HIGH POINT - GUN CLUB TO 61ST AVENUE EXTENSION INFRASTRUCTURE SITE PLAN

Date	Submission / Revision
02/28/24	1st ISP Submittal
06/28/24	2nd ISP Submittal

HIGH POINT - GUN CLUB TO 61ST AVENUE EXTENSION INFRASTRUCTURE SITE PLAN

OVERALL
SITE PLAN ??

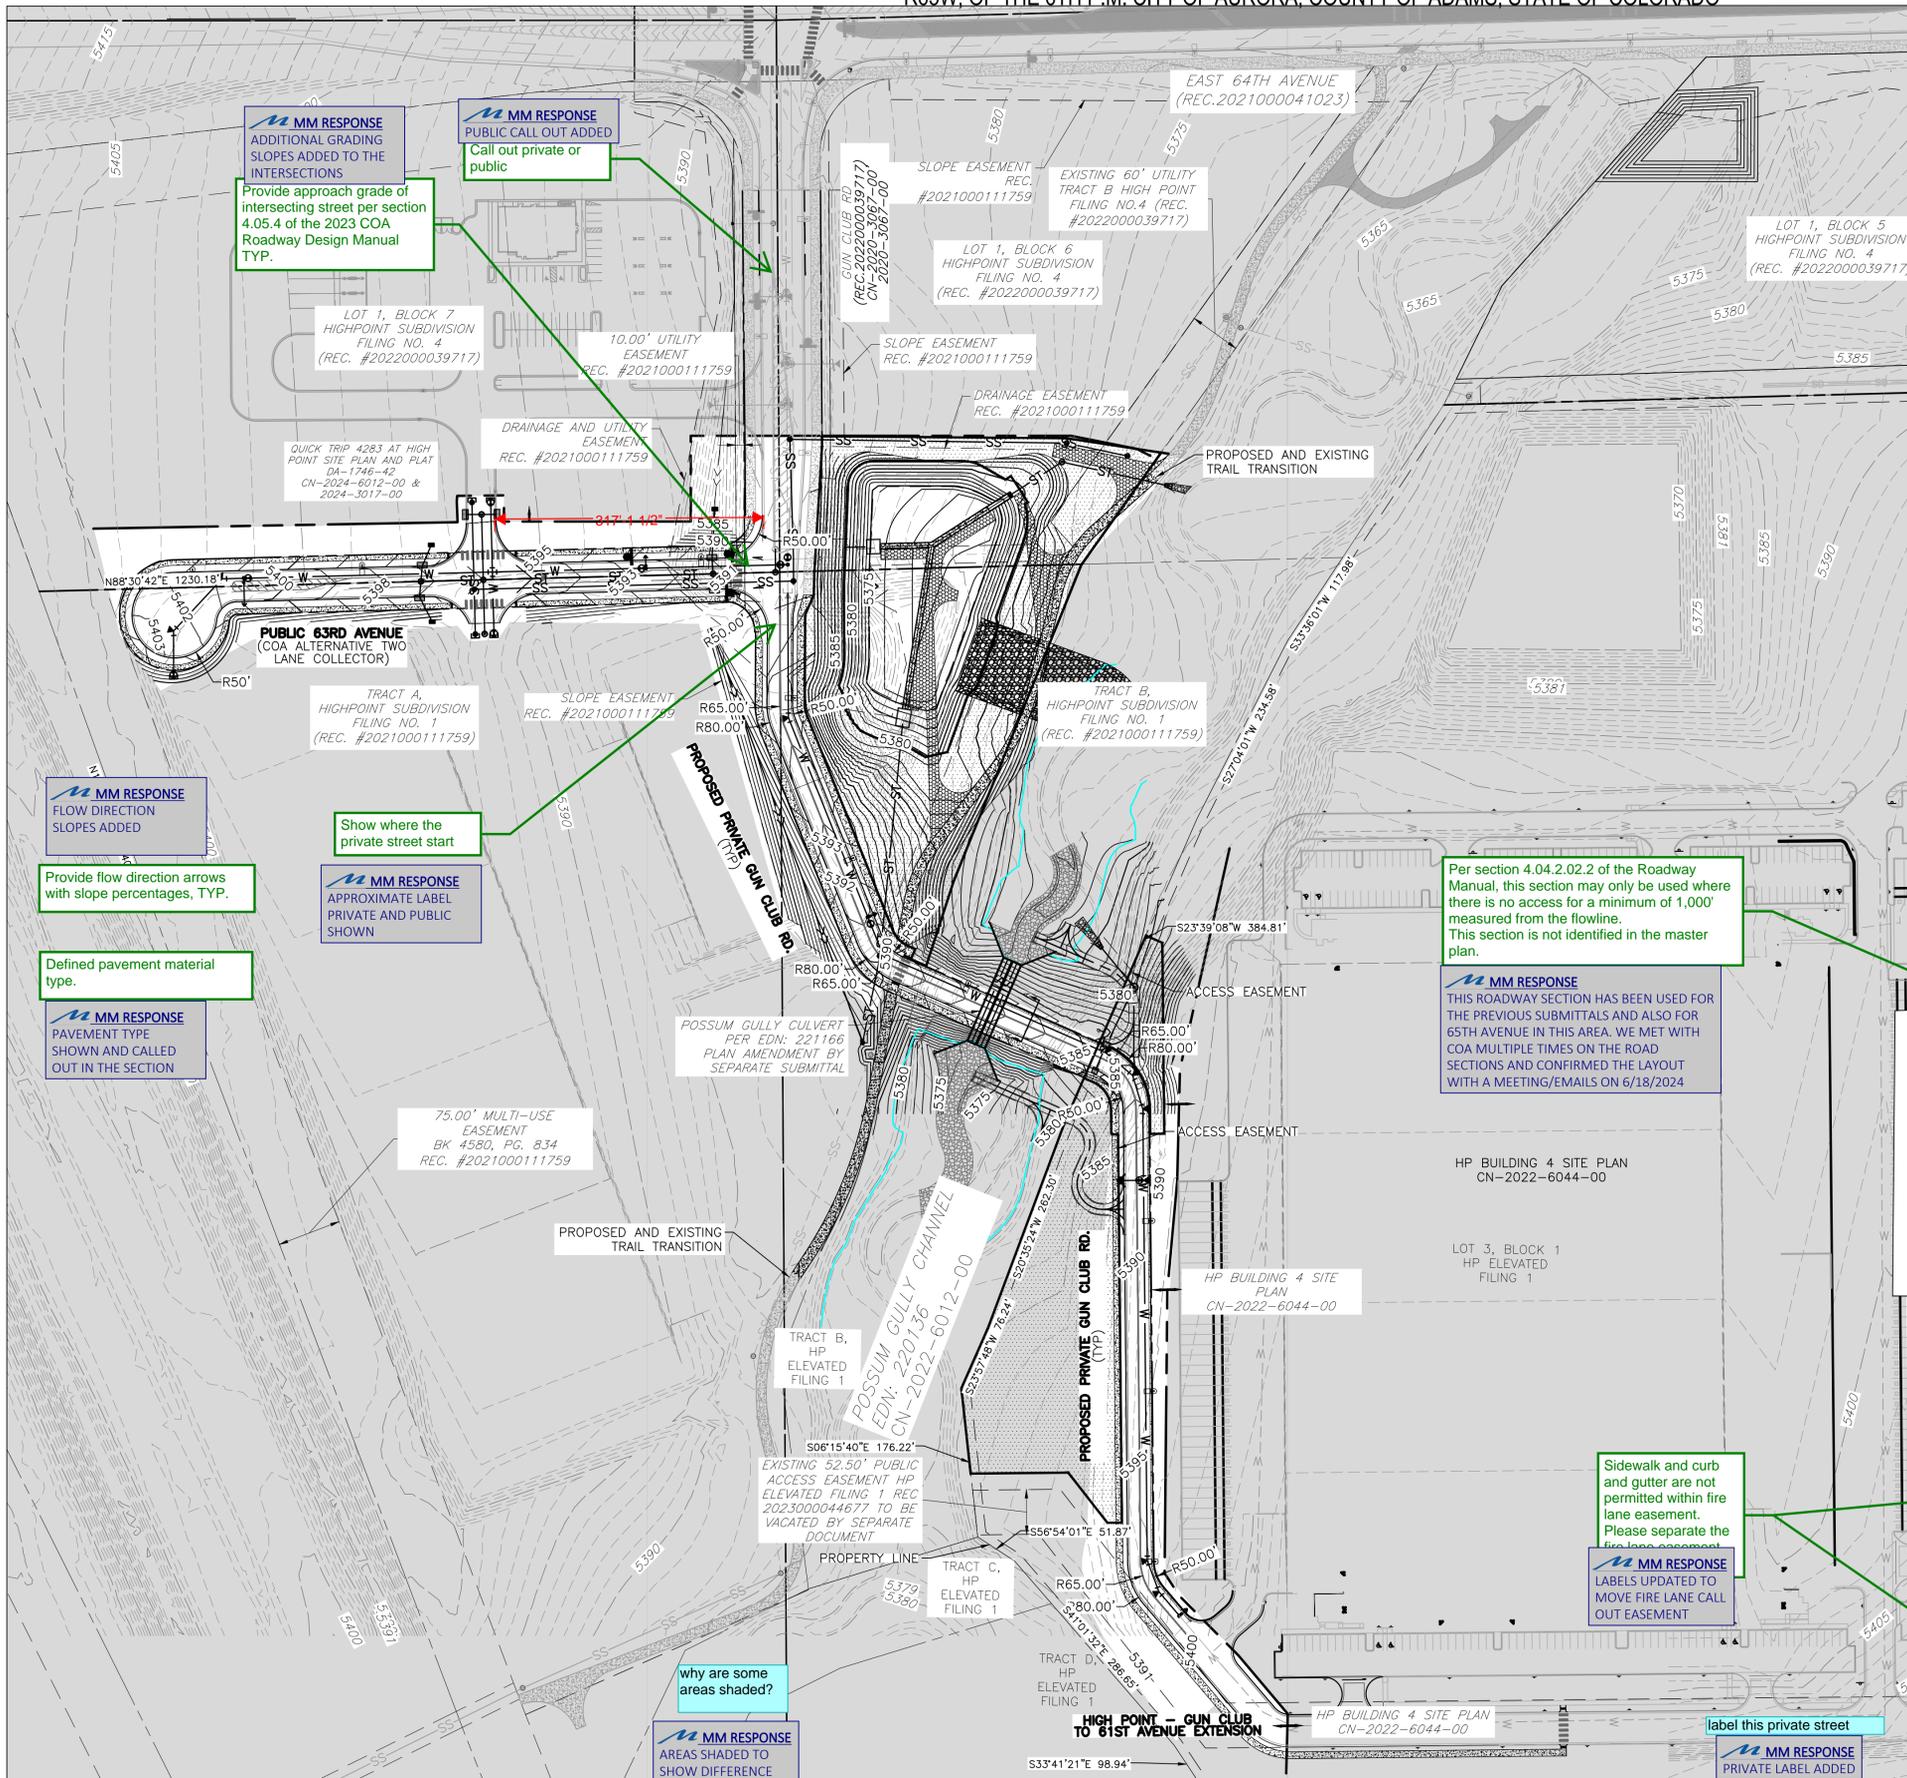
- MM RESPONSE** ADDITIONAL GRADING SLOPES ADDED TO THE INTERSECTIONS
- Provide approach grade of intersecting street per section 4.05.4 of the 2023 COA Roadway Design Manual TYP.

- MM RESPONSE** PUBLIC CALL OUT ADDED
- Call out private or public
- LOT 1, BLOCK 7 HIGHPOINT SUBDIVISION FILING NO. 4 (REC. #202200039717)
- 10.00' UTILITY EASEMENT REC. #202100011759

- PROPOSED PRIVATE GUN CLUB RD.
- MM RESPONSE** FLOW DIRECTION SLOPES ADDED
- Provide flow direction arrows with slope percentages, TYP.
- Show where the private street start

- MM RESPONSE** APPROXIMATE LABEL PRIVATE AND PUBLIC SHOWN
- Defined pavement material type.
- MM RESPONSE** PAVEMENT TYPE SHOWN AND CALLED OUT IN THE SECTION

- TRACT C, HP ELEVATED FILING 1
- TRACT D, HP ELEVATED FILING 1
- HP BUILDING 4 SITE PLAN CN-2022-6044-00
- why are some areas shaded?
- MM RESPONSE** AREAS SHADED TO SHOW DIFFERENCE BETWEEN THIS PROJECT AND OTHER PROJECTS

- label this private street
- MM RESPONSE** PRIVATE LABEL ADDED

Per section 4.04.2.02.2 of the Roadway Manual, this section may only be used where there is no access for a minimum of 1,000' measured from the flowline. This section is not identified in the master plan.

Sidewalk and curb and gutter are not permitted within fire lane easement. Please separate the fire lane easement

Overall site plan, overall grading, over utilities...? TYP.

MM RESPONSE THIS ROADWAY SECTION HAS BEEN USED FOR THE PREVIOUS SUBMITTALS AND ALSO FOR 65TH AVENUE IN THIS AREA. WE MET WITH COA MULTIPLE TIMES ON THE ROAD SECTIONS AND CONFIRMED THE LAYOUT WITH A MEETING/EMAILS ON 6/18/2024

MM RESPONSE LABELS UPDATED TO MOVE FIRE LANE CALL OUT EASEMENT

MM RESPONSE SITE PLAN SPECIFIC LABEL ADDED

Drawing Title
LANDSCAPE NOTES & TABLES

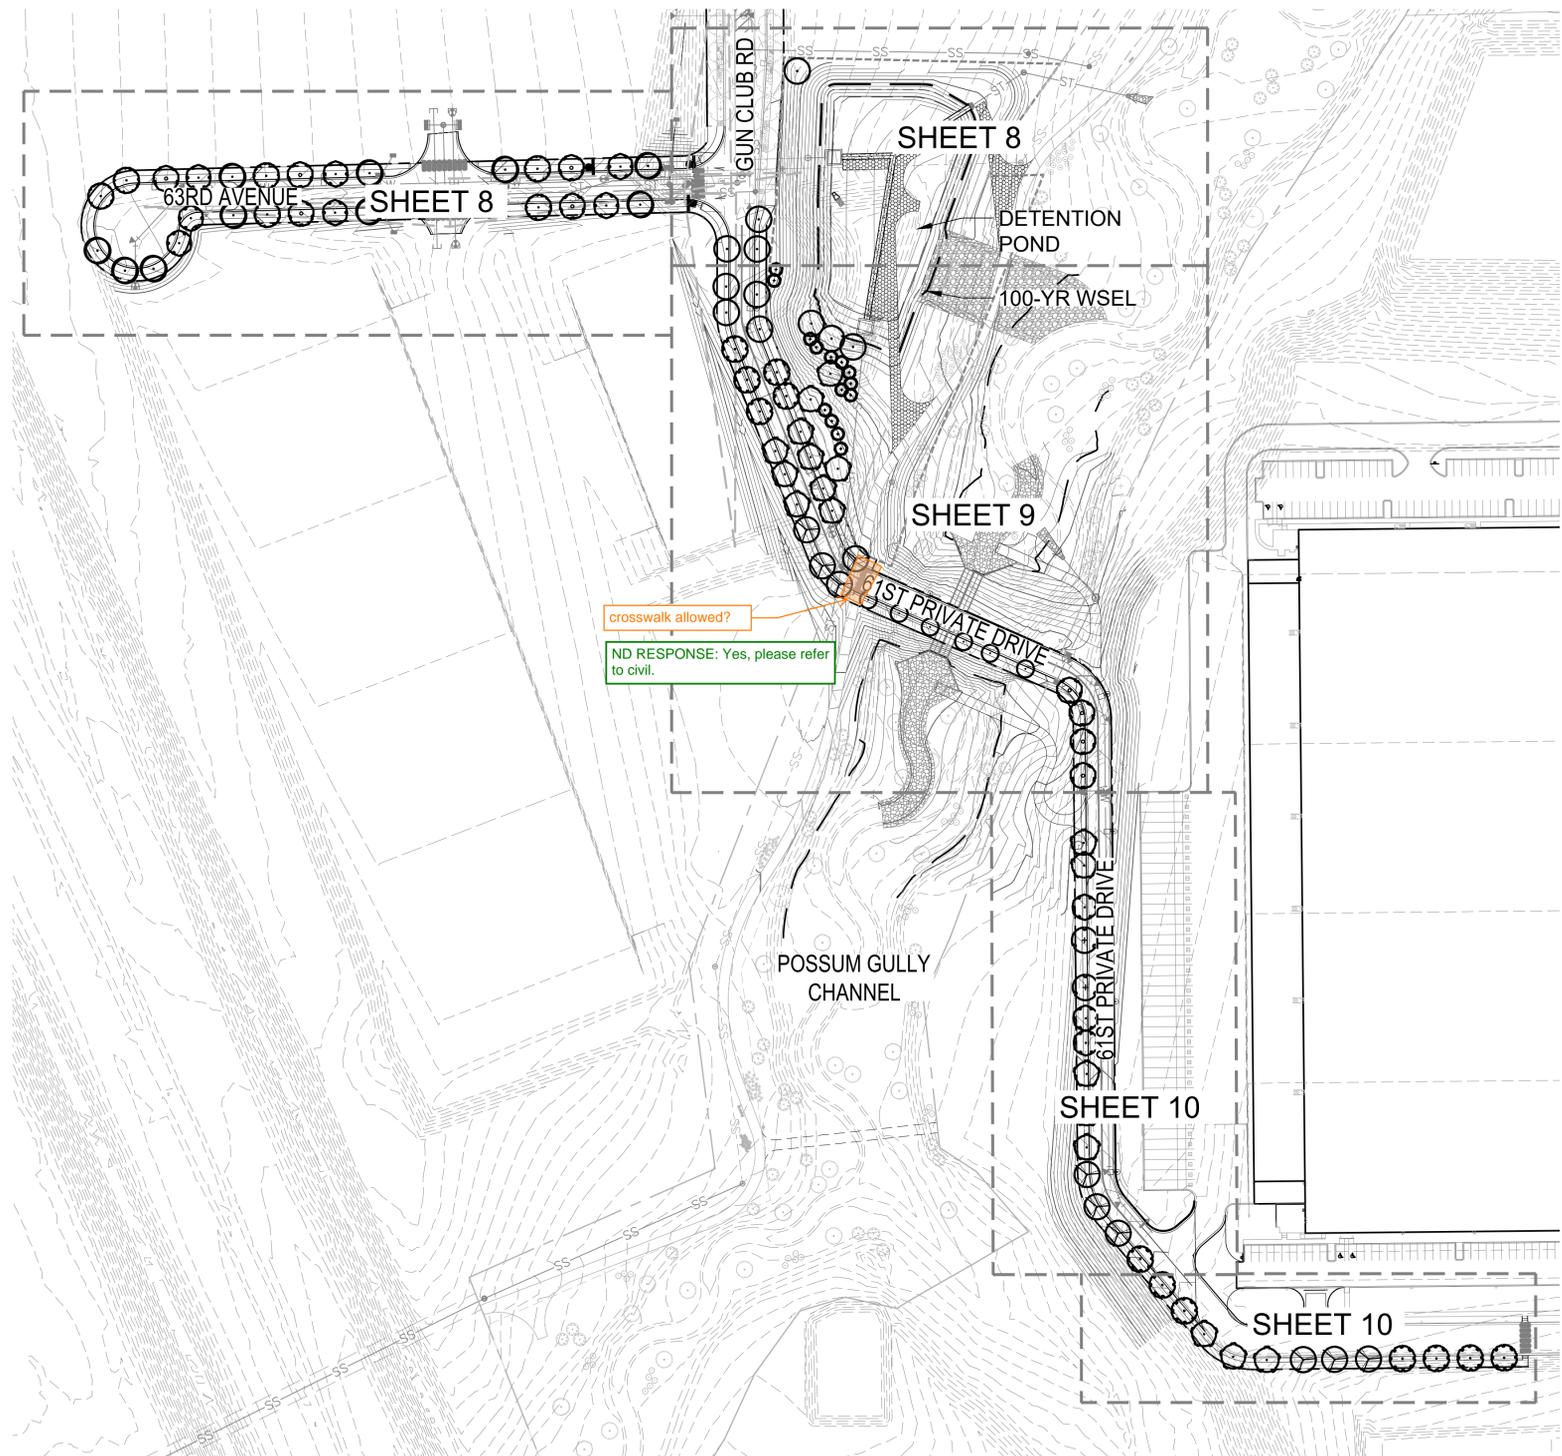
- Shrubs shown in table are a minimum of container #5 Size
- 0.025 Shrubs per 1 Square Foot of curbside area. **ND RESPONSE: Updated.**
- 1 Tree per 40 LF
- Distances measured between tangent points, intersecting drives are excluded.
- One tree equivalent shall be equal to: Twelve 5 gallon shrubs per one 2.5 inch caliper tree
- One shrub equivalent shall be equal to: Three 1 gallon ornamental grasses

5 gallon **ND RESPONSE: Updated.**

LANDSCAPE PLAN

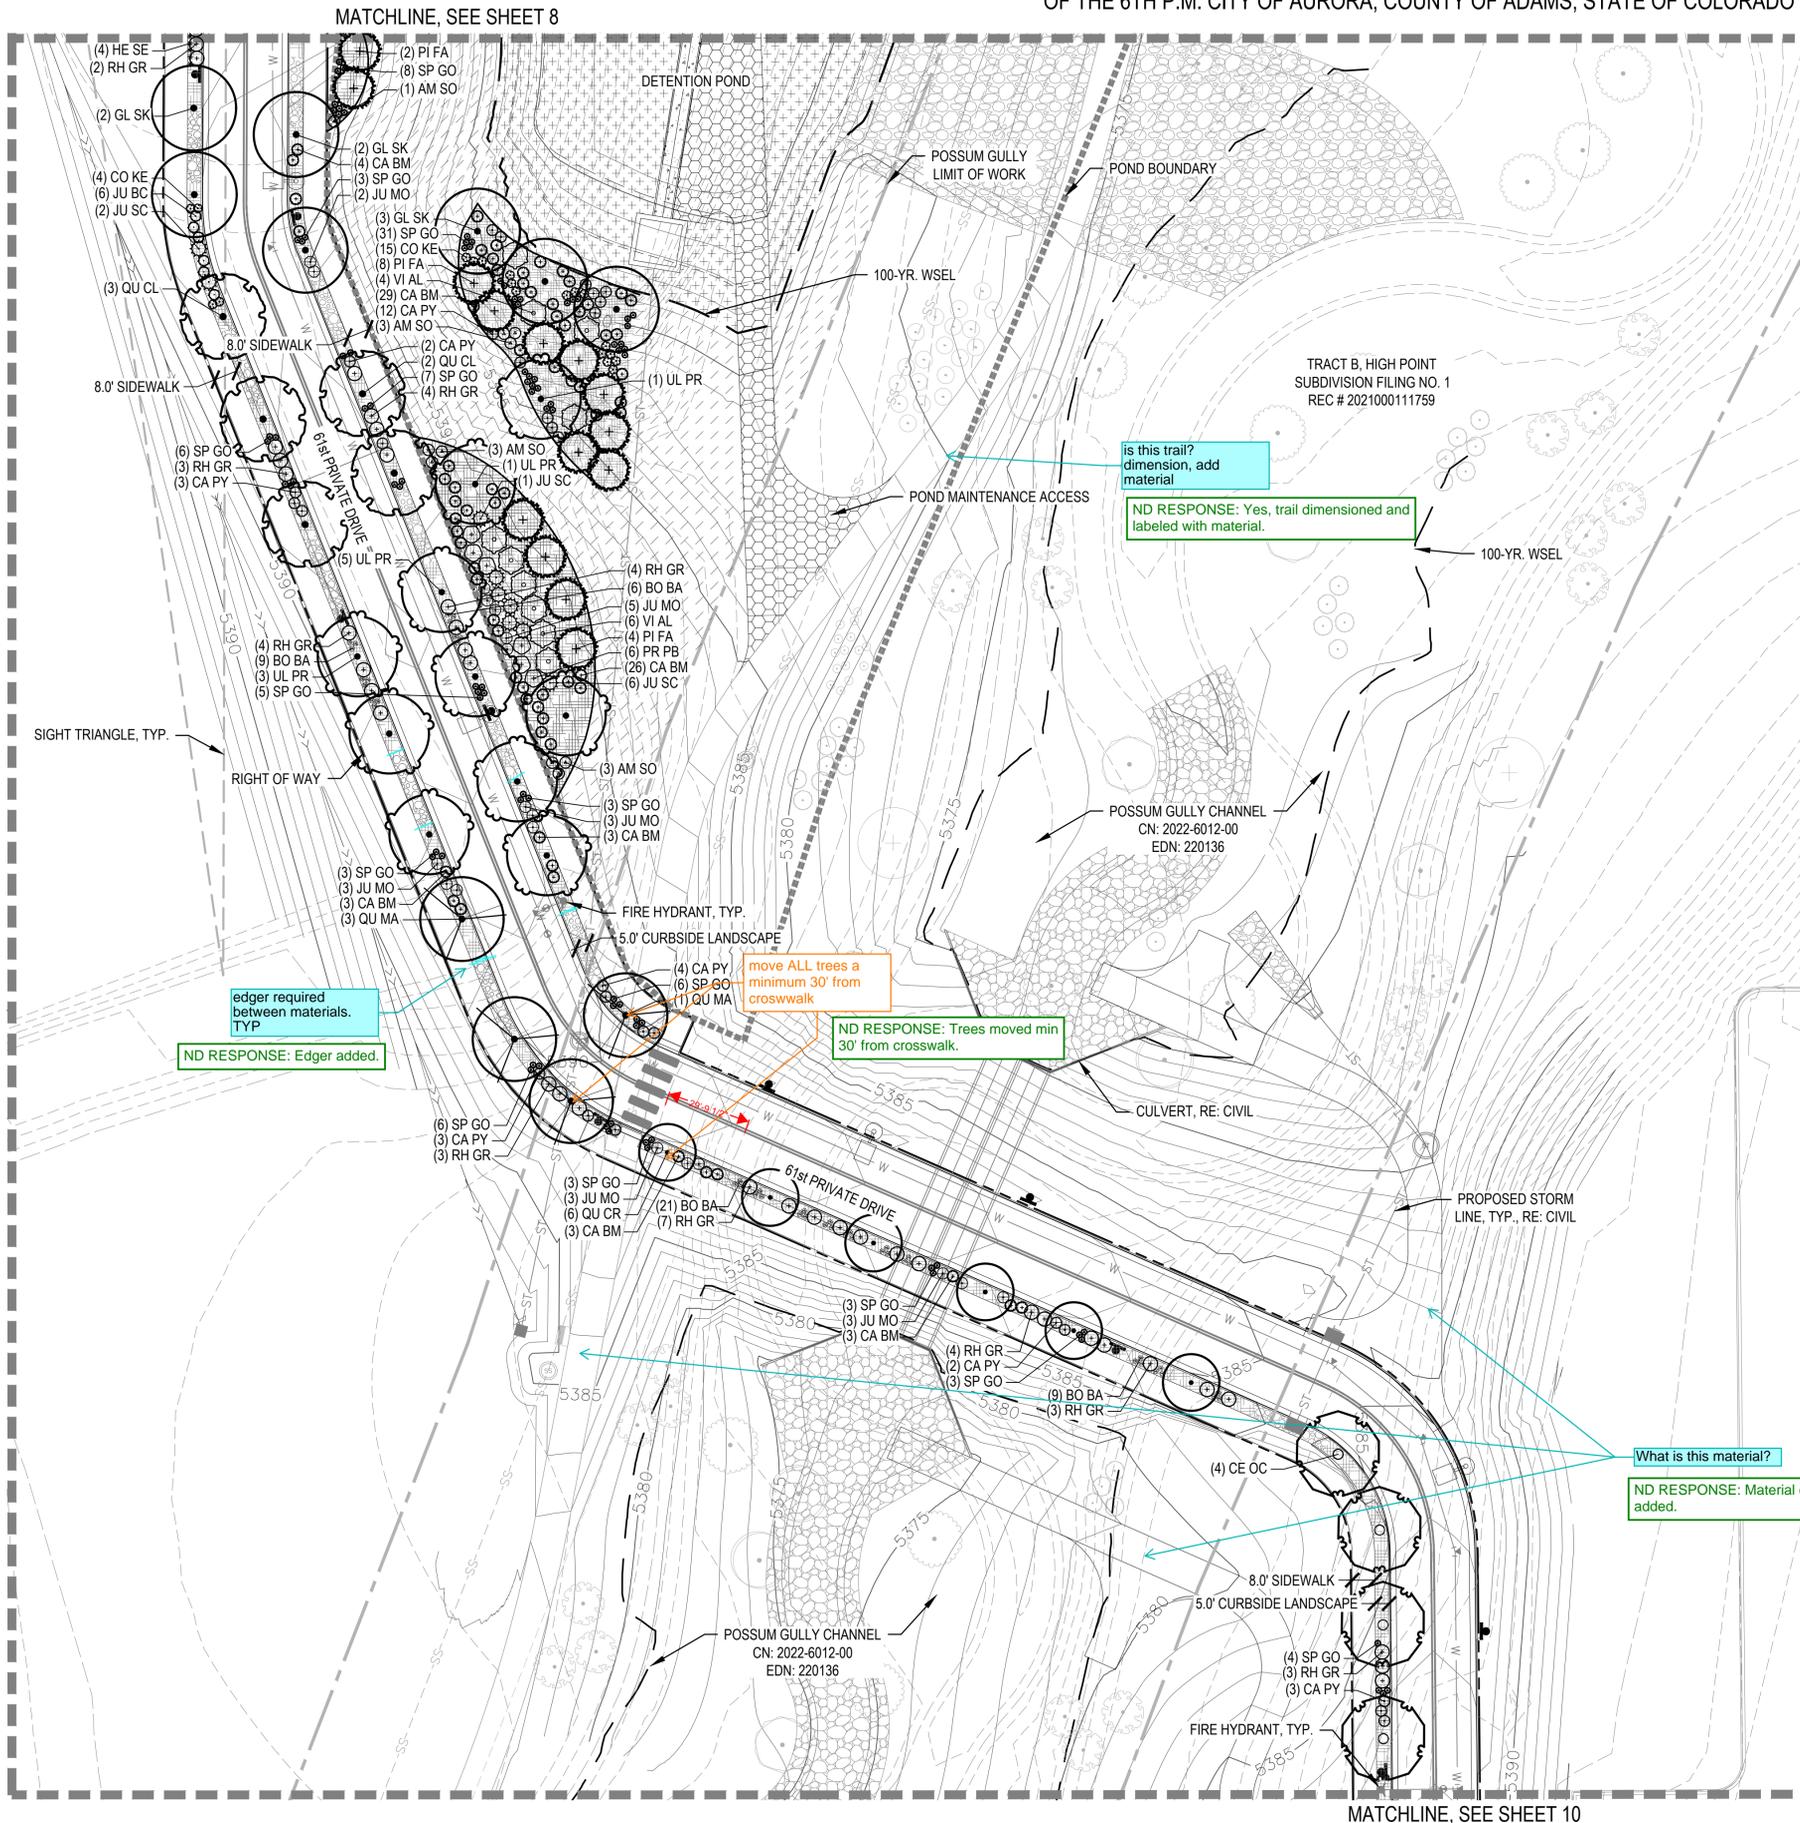
edger required between materials, TYP.
ND RESPONSE: Edger added.

move ALL trees a minimum 30' from crosswalk
ND RESPONSE: Trees moved min 30' from crosswalk.

is this trail? dimension, add material
ND RESPONSE: Yes, trail dimensioned and labeled with material.

What is this material?
ND RESPONSE: Material callouts added.
